Conformance Set

SITE GRADING PLAN
 TOWN BRANCH WET WEATHER STORAGE FACILITY
 REMEDIAL MEASURES PLAN ID No. G2-TB-1

**Permitting, Inspection, and Enforcement Procedures for
Erosion and Sediment Control on Capital Projects
Division of Water Quality Remedial Measures Plan (RMP)**

C-0-103

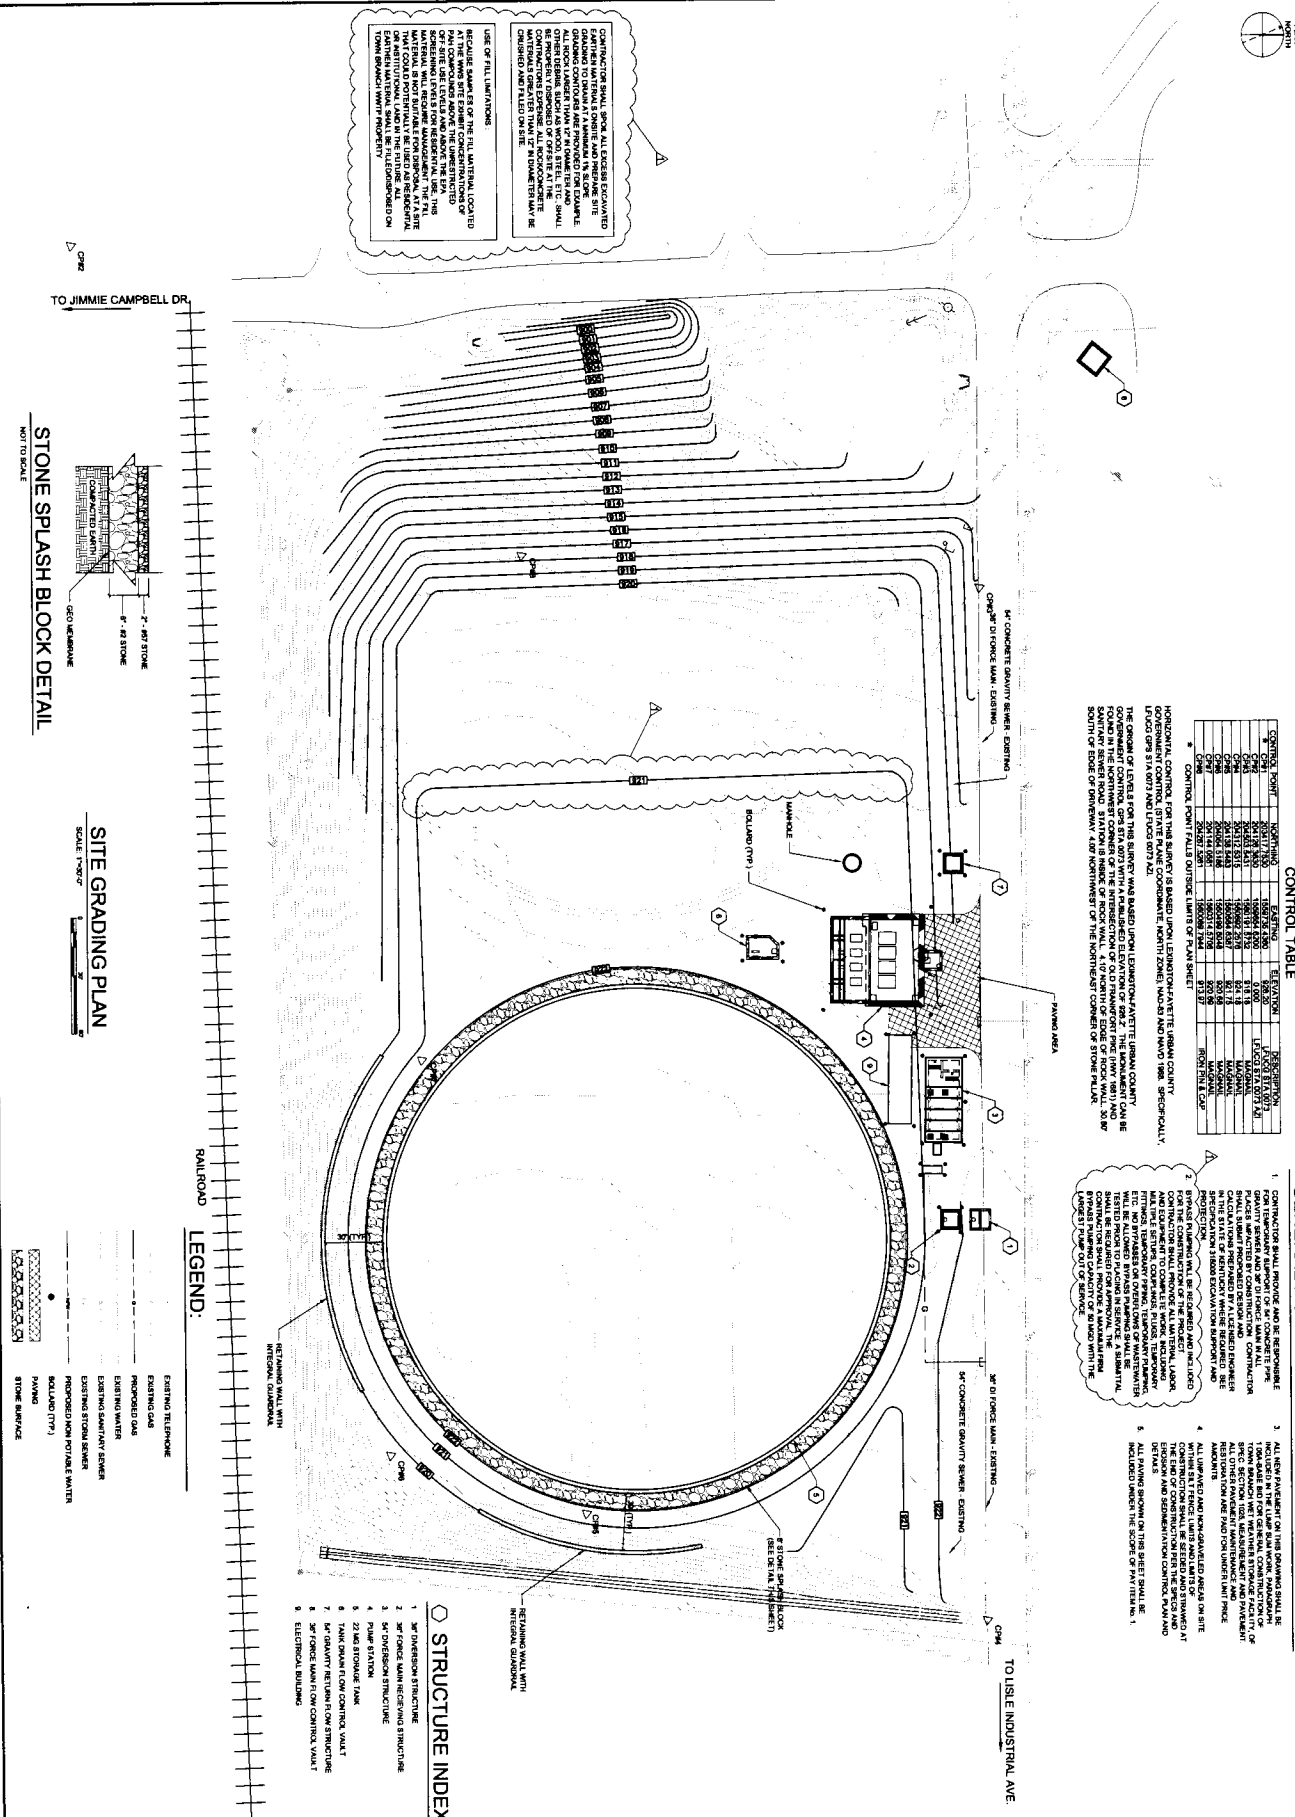
95	Sheet C-0-103 indicates two locations for "Retaining Wall with Integral Guardrail". Nowhere else in the drawings or specifications are details or other pertinent information pertaining to the intended guardrail system found. Please provide additional guidance for this feature.	See addenda and Sheet C-0-506 for guardrail system detail.
96	Can some or all of the affected portions of the existing 54" gravity sewer line be left in place and reused as part of the new system?	The 54" gravity sewer between structure no. 2 (36" force main receiving structure) and structure no. 7 (54" gravity return flow structure) shall be replaced. No existing pipe may remain.

AUGUST, 2014
 1/8" = 1'-0"
 C-8-101

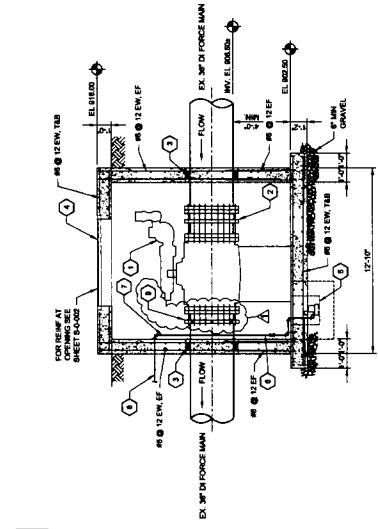
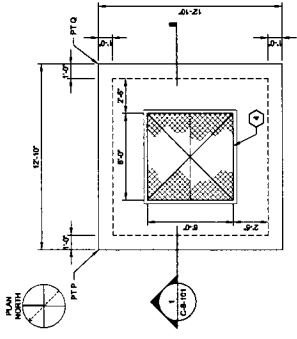
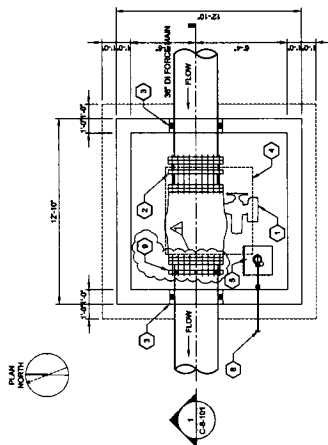
- A. Add the following to the General Notes:
 - 2. Contractor shall remove a section of the existing 36" force main in order to install the flow control valve.
 - 3. The valve and dismantling joint shall be restrained in two (2) locations with utilization of a Megaflange or equal.

Exhibit B

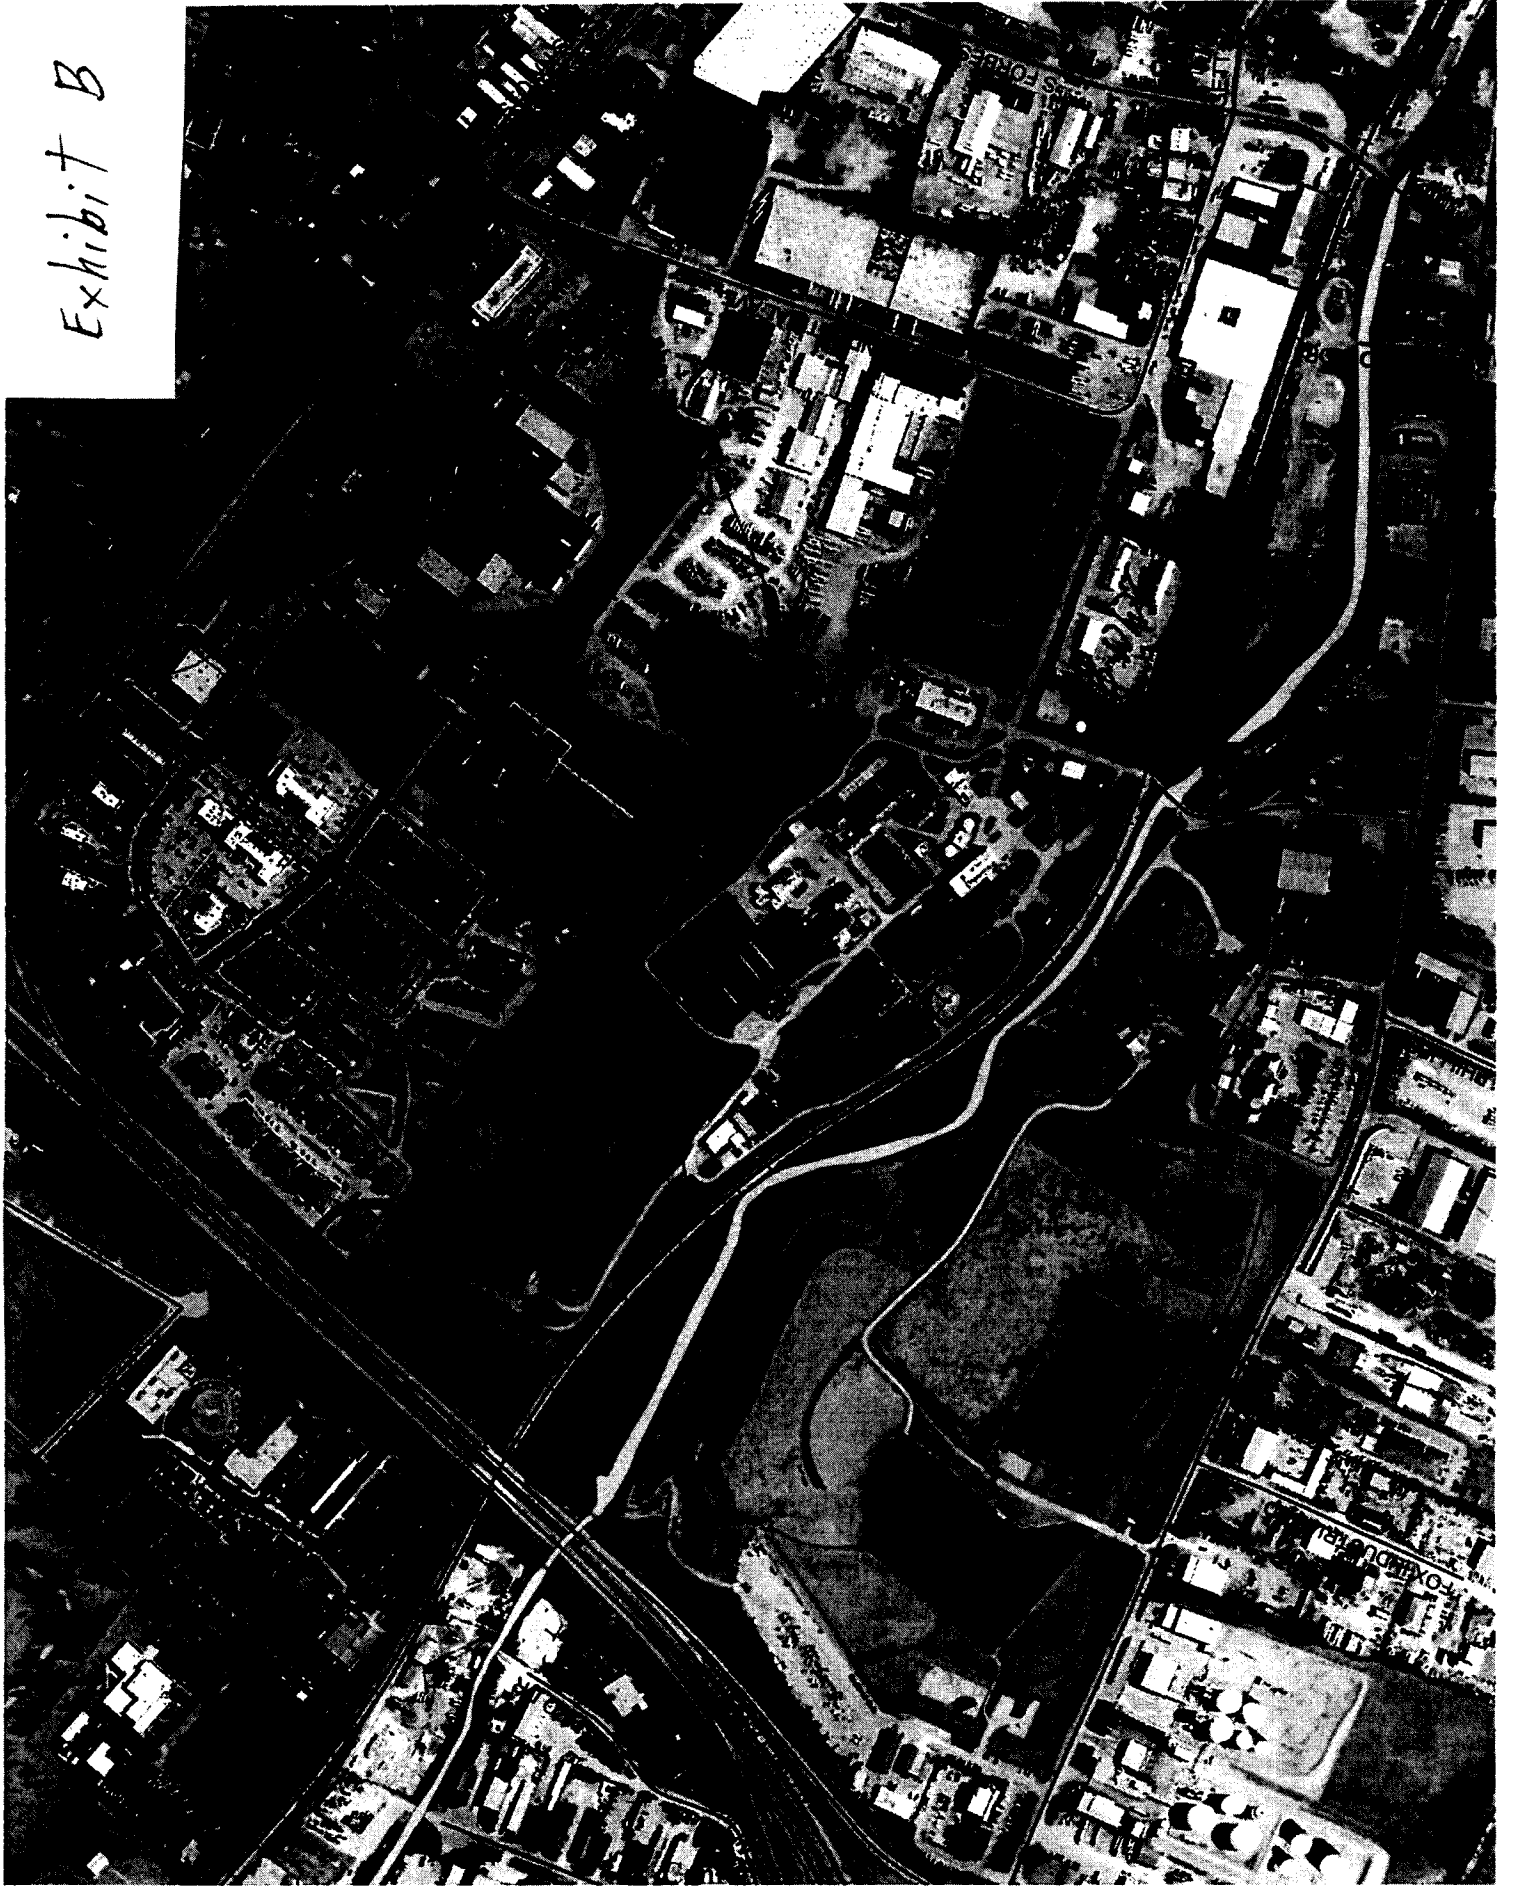
- 1- To use a thicker line marking the limit of land disturbance.
- 2- "Esc" inlets will be inspected; once a week, or every (10) days and after a rainfall event of 0.5 inches.
- 3- To provide detail of the concrete washout pit such as; size & method of construction above ground / under ground.
- 4- construction entrance to be underlined with geotextile fabric and covered with #2 stone.
- 5- Drawing G2-TB1, to provide detail of silt fence stabilization, concrete, silt fence should not cross contour.
